**ADDENDUM NO. 3**

IRONDALE FIRE STATION No. 3

THIS ADDENDUM FORMS A PART OF THE CONTRACT DOCUMENTS. THE FOLLOWING CONDITIONS TAKE PRECEDENCE OVER ANY CONFLICTING CONDITIONS IN THE DRAWINGS AND SPECIFICATIONS. THE DRAWINGS AND SPECIFICATIONS ARE HEREBY AMENDED IN THE FOLLOWING PARTICULARS.

SHEET NUMBER  
**C4.2**

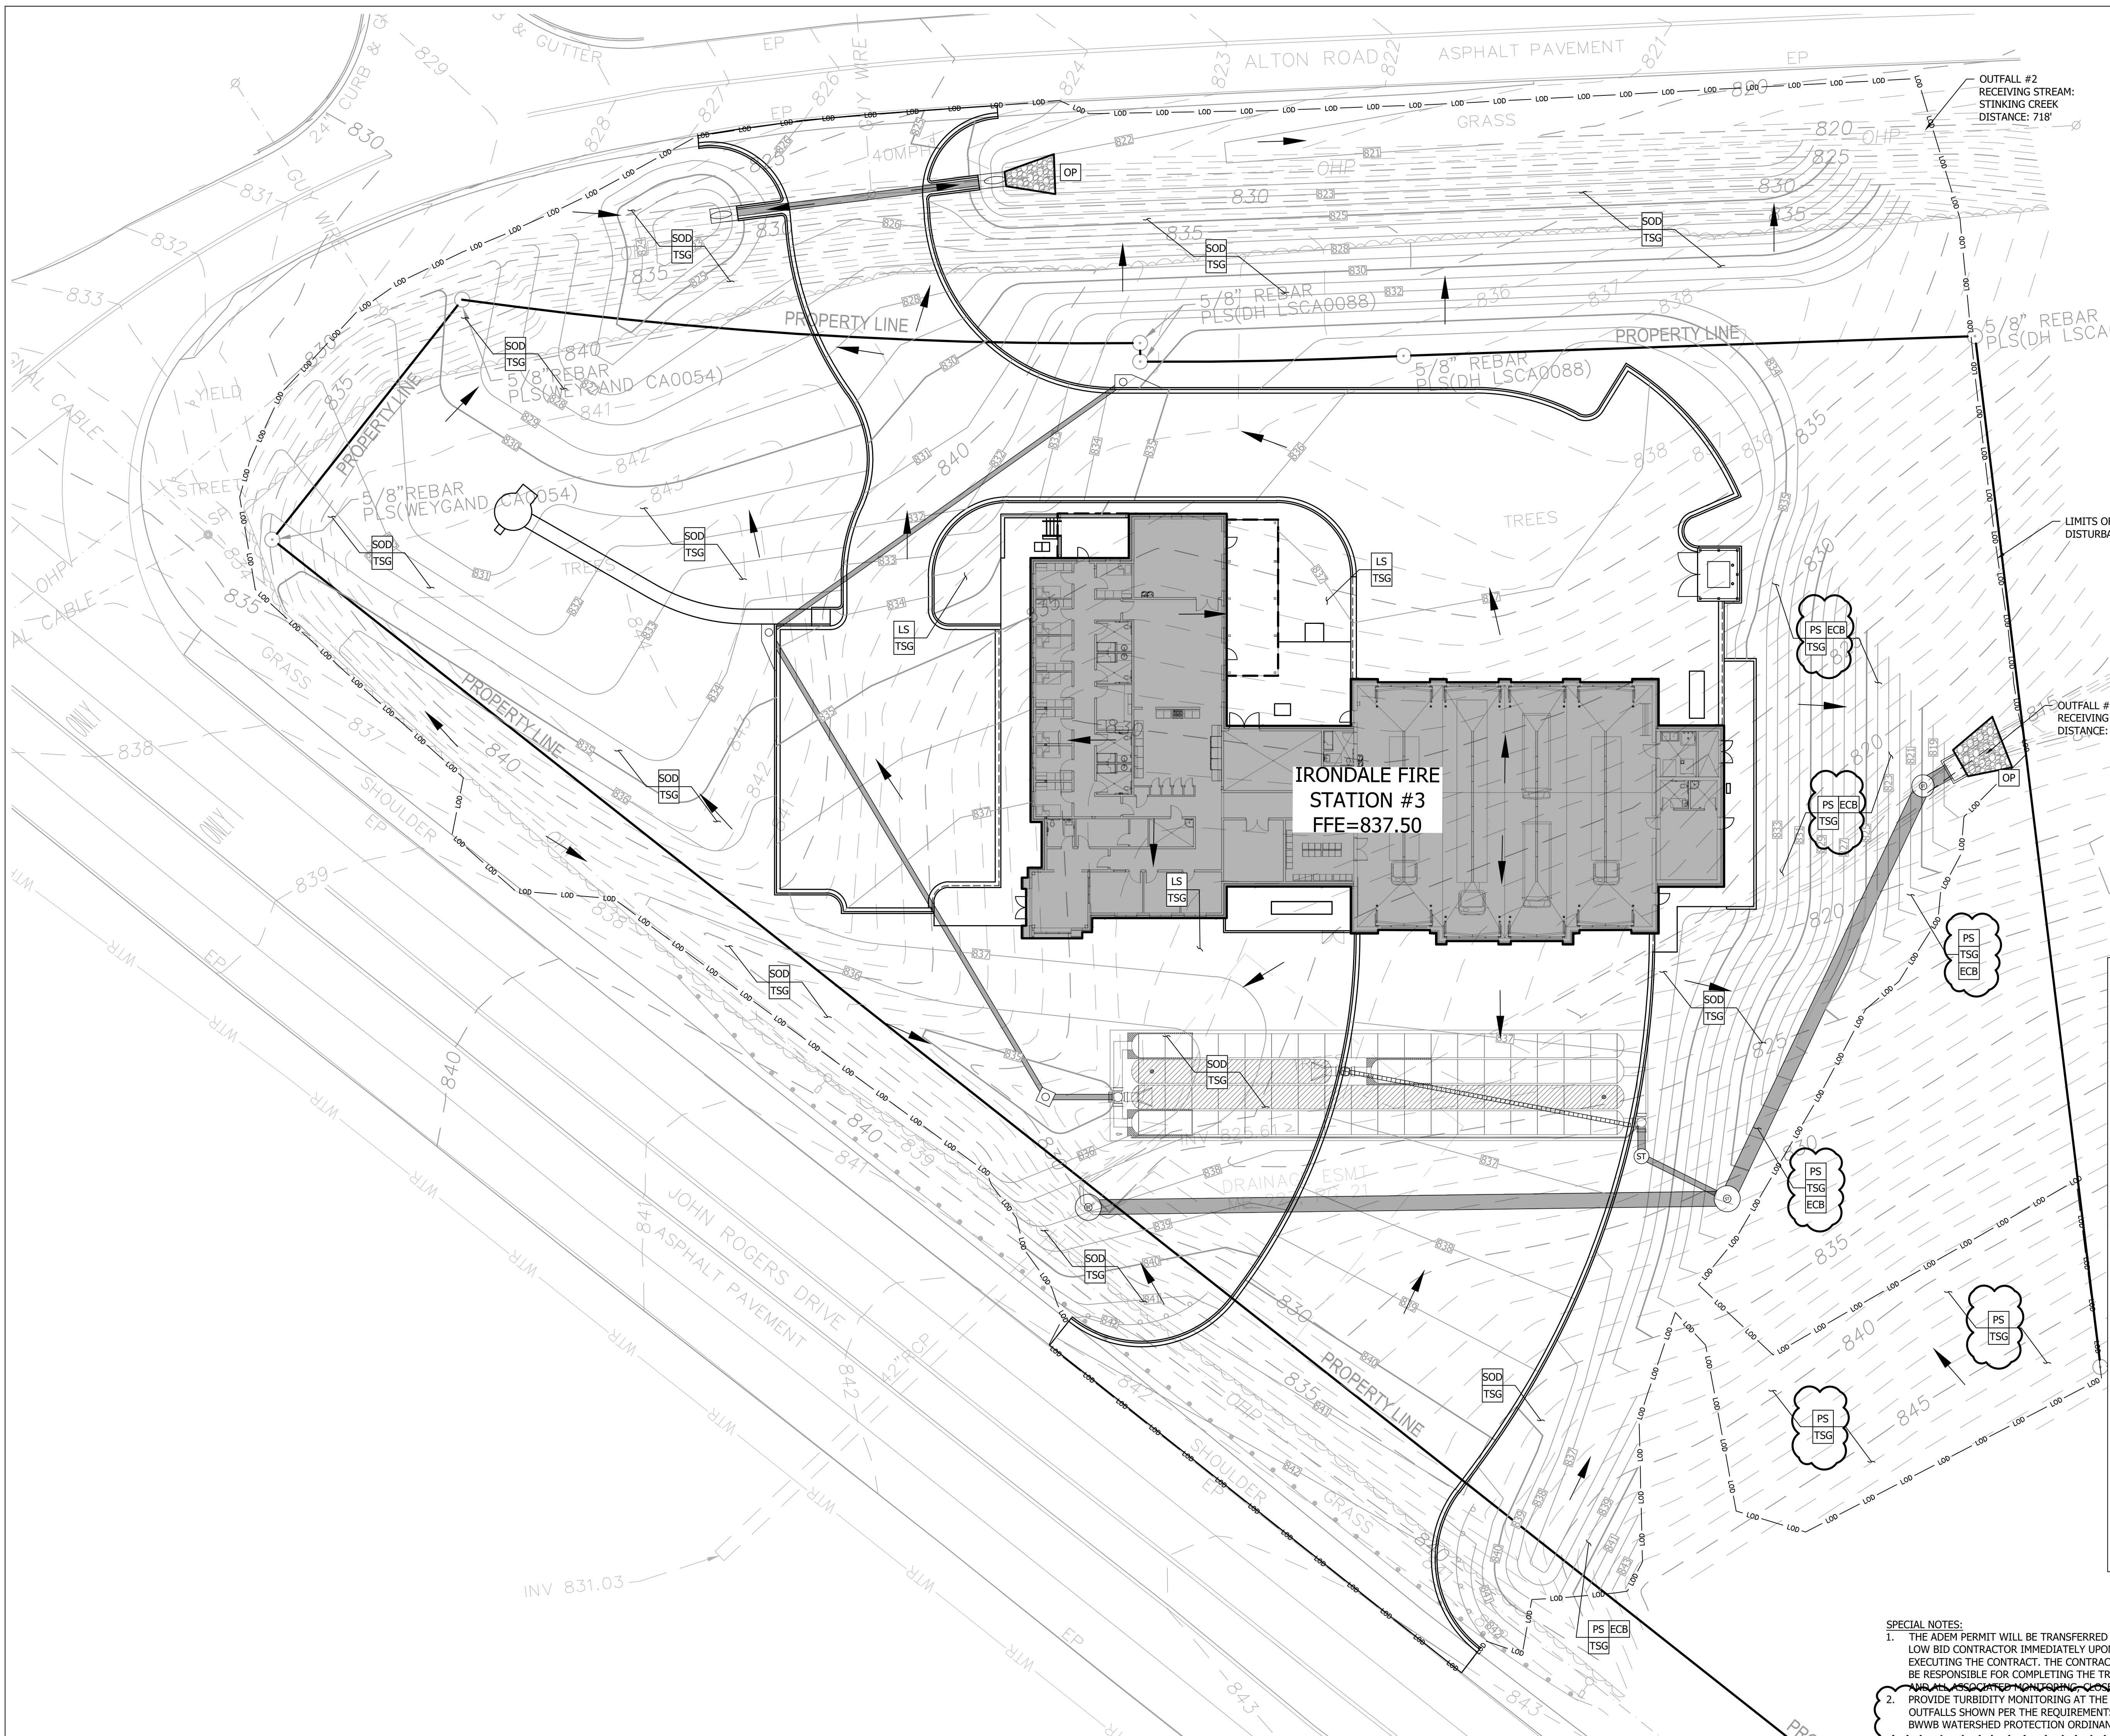
6. C4.2 Erosion Control Plan – Final:
- a. Changed temporary seeding callouts to permanent seeding and removed surface roughening from final phase.
  - b. Added special note 3 regarding turbidity monitoring requirements

**C5.4**

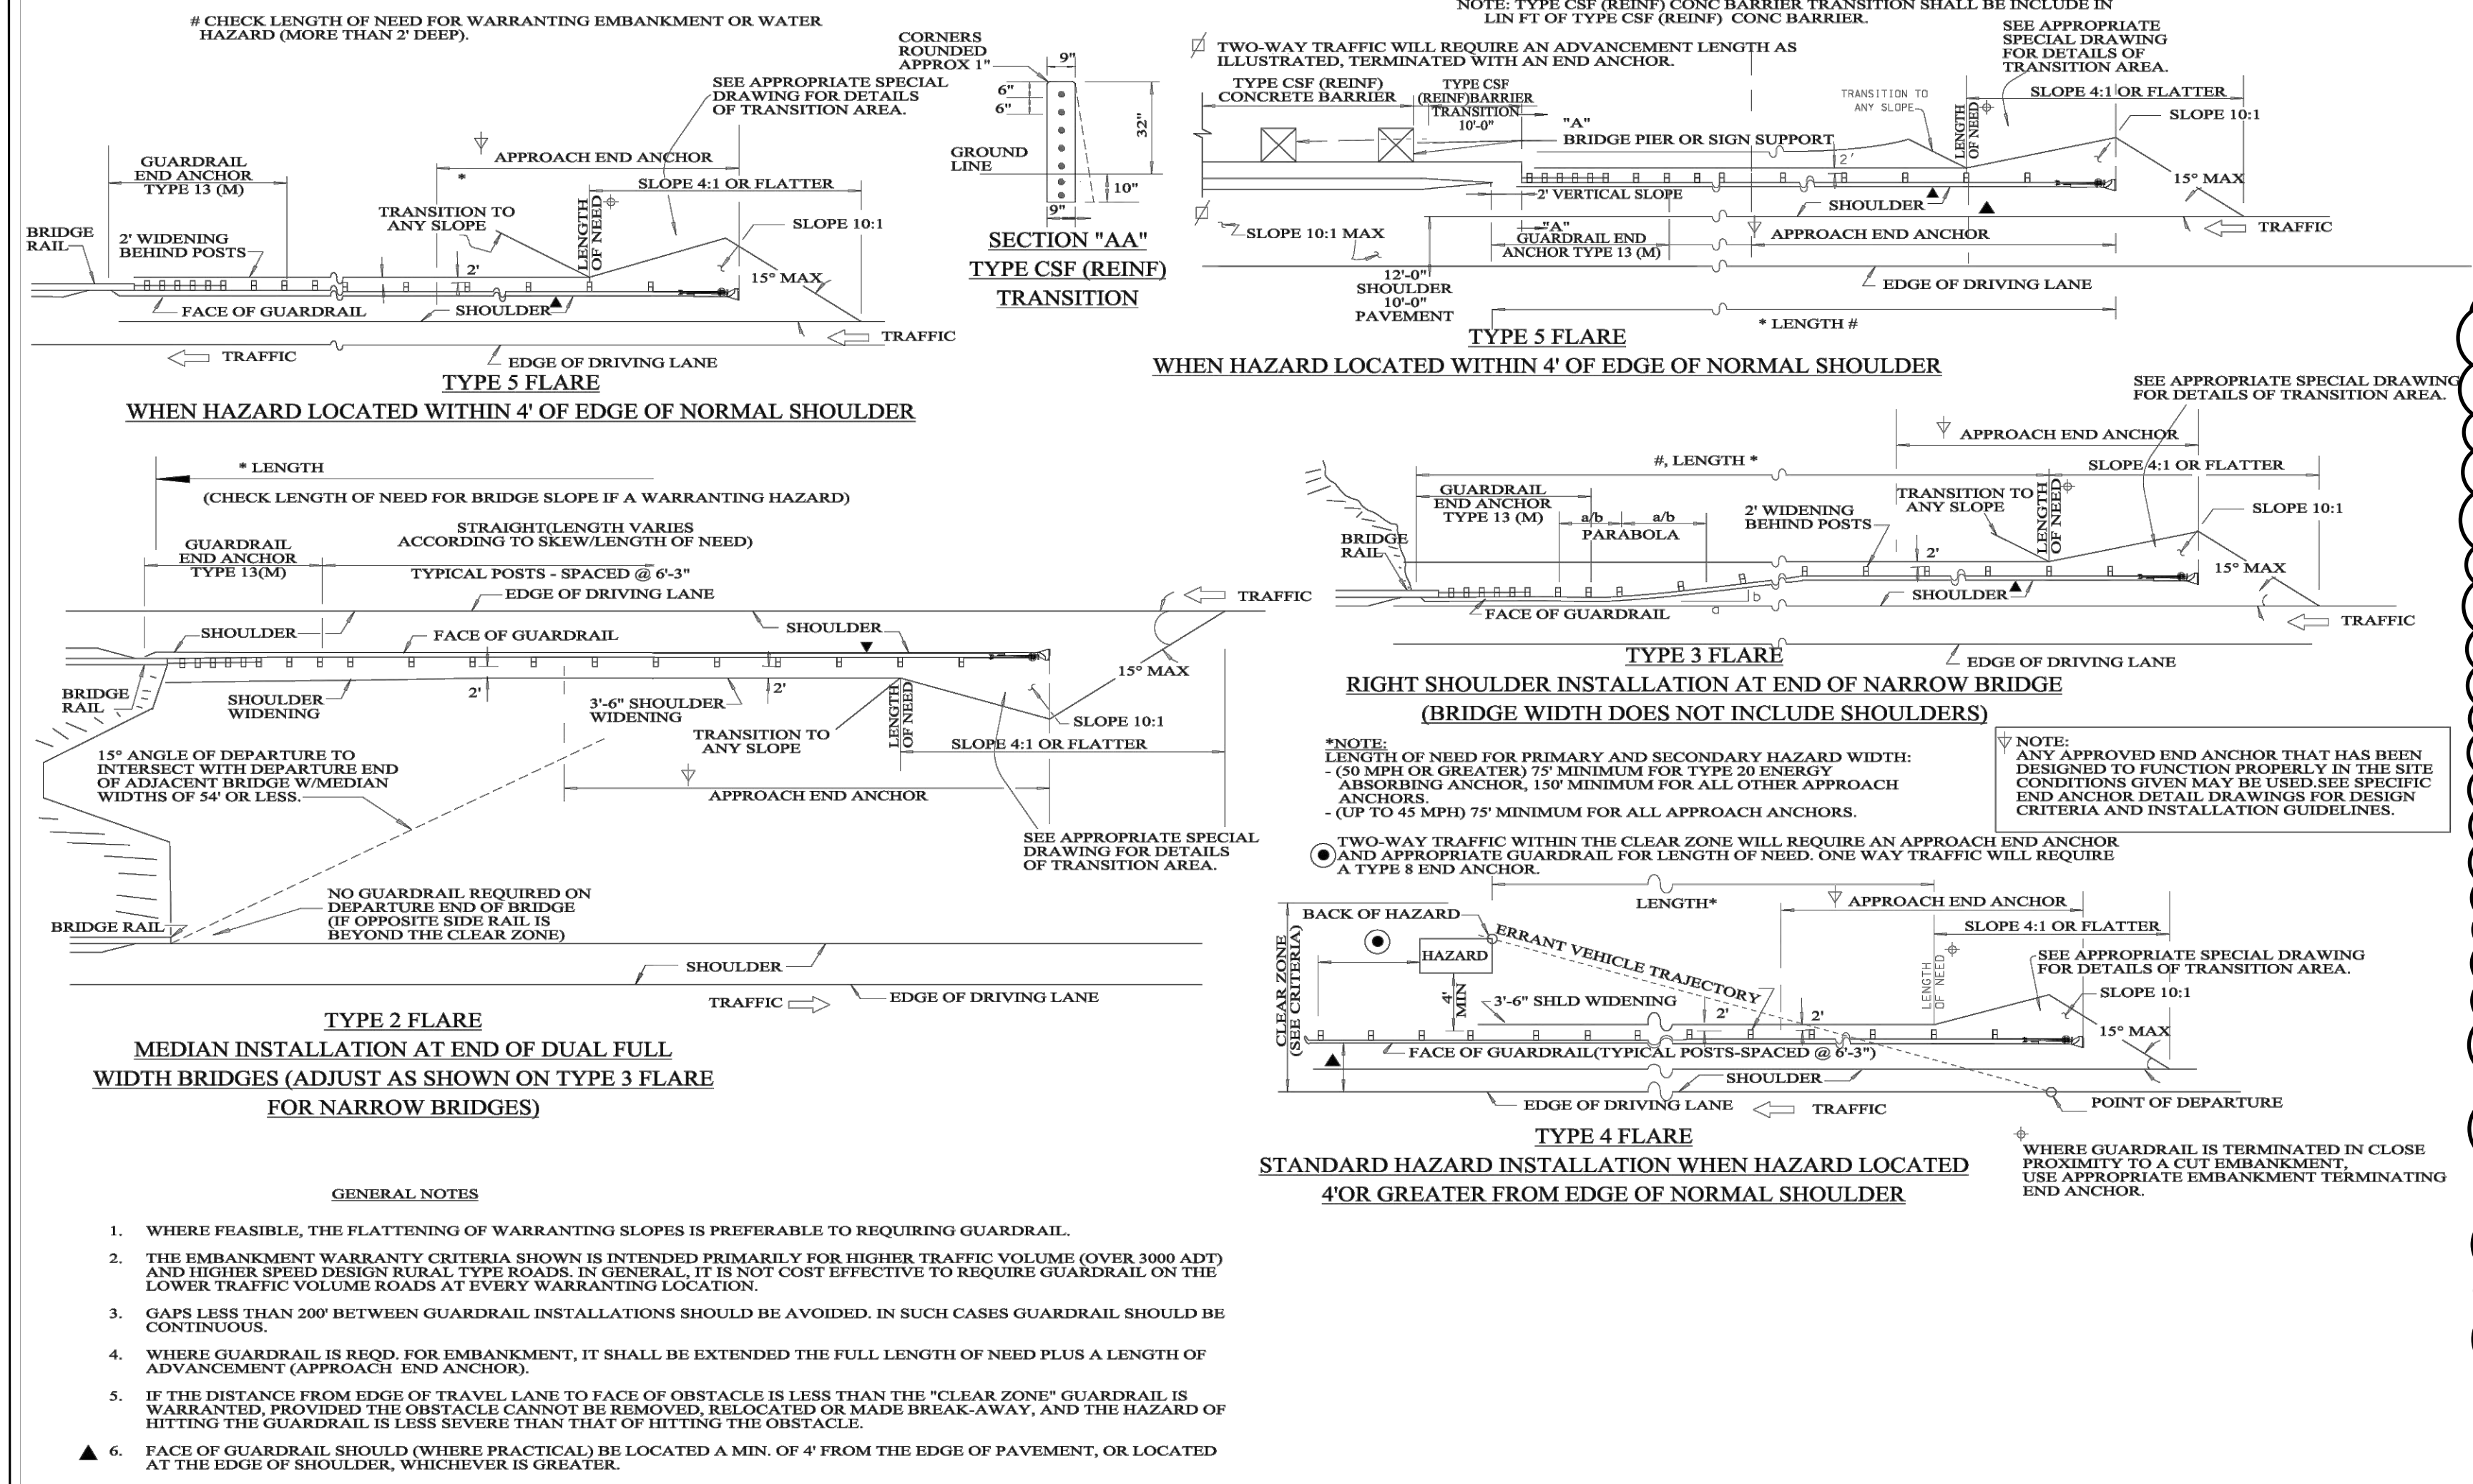
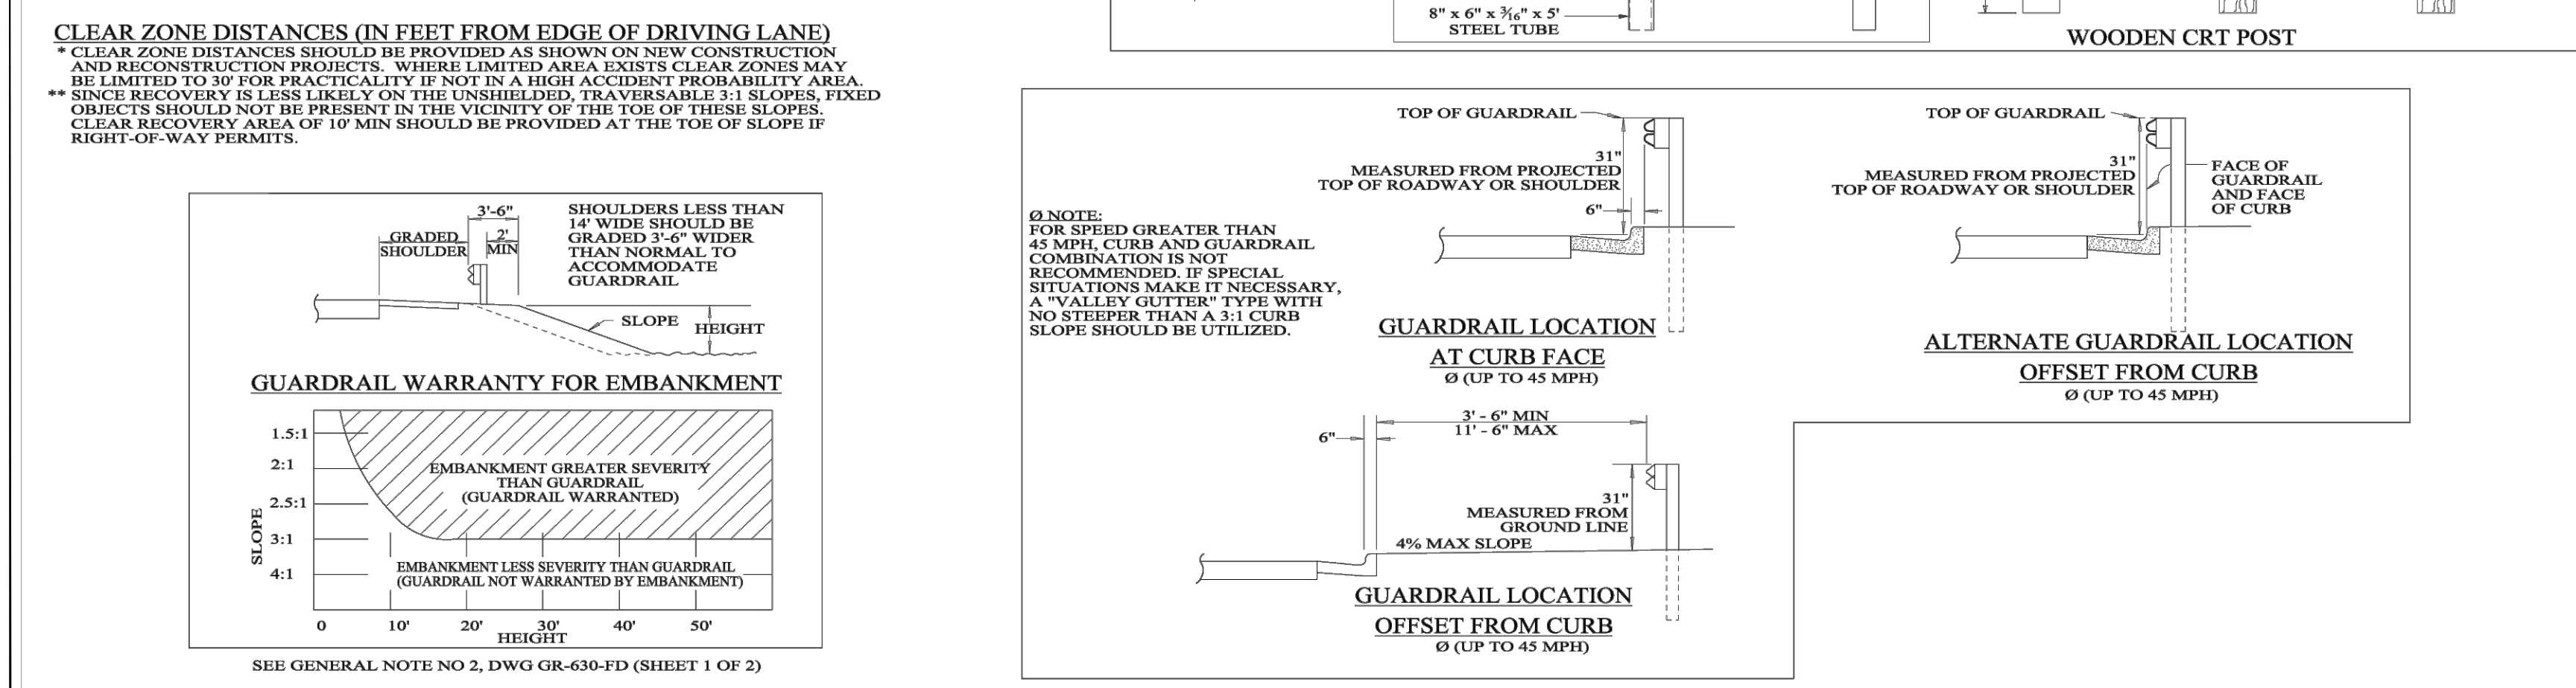
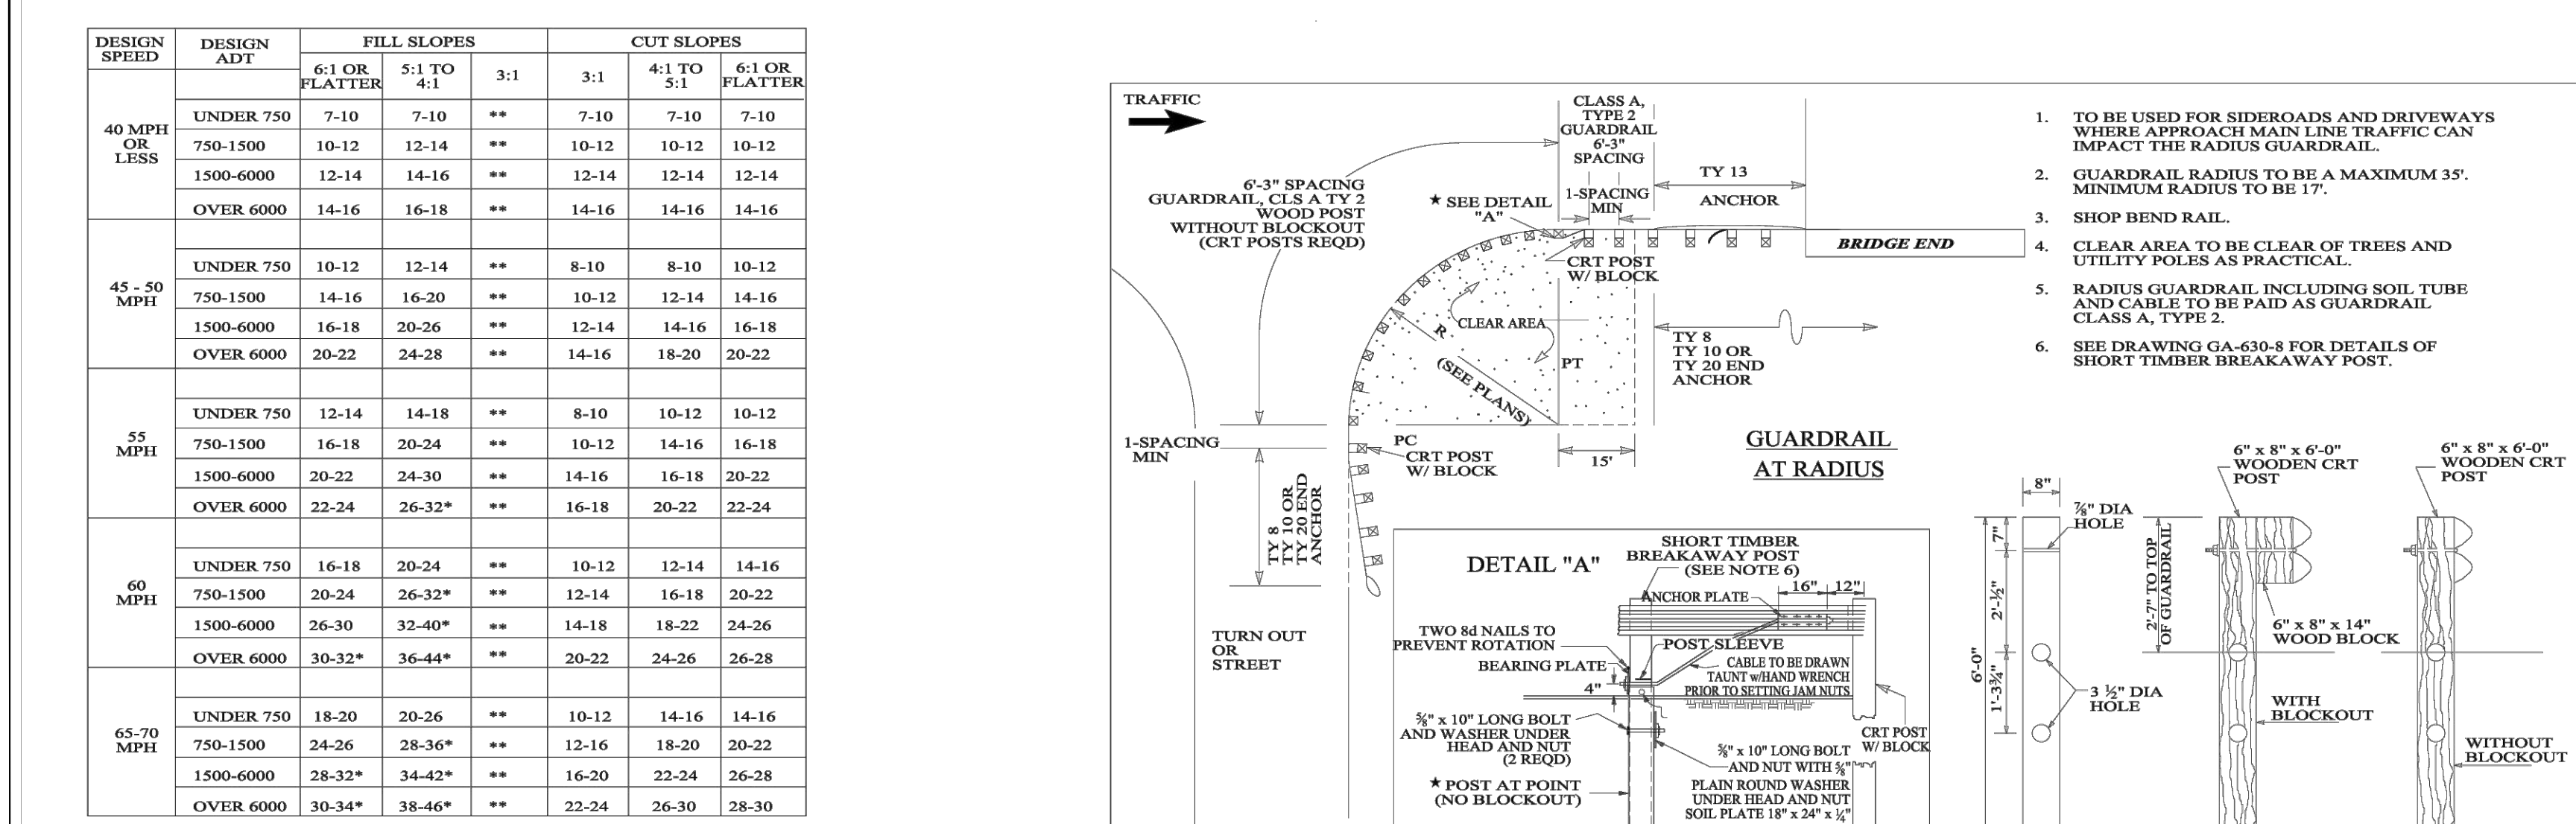
8. C5.4 Details:
- a. Added mulching, temporary, and permanent seeding detail
  - b. Added diversion berm detail
  - c. Added Headwall detail for structure #A1
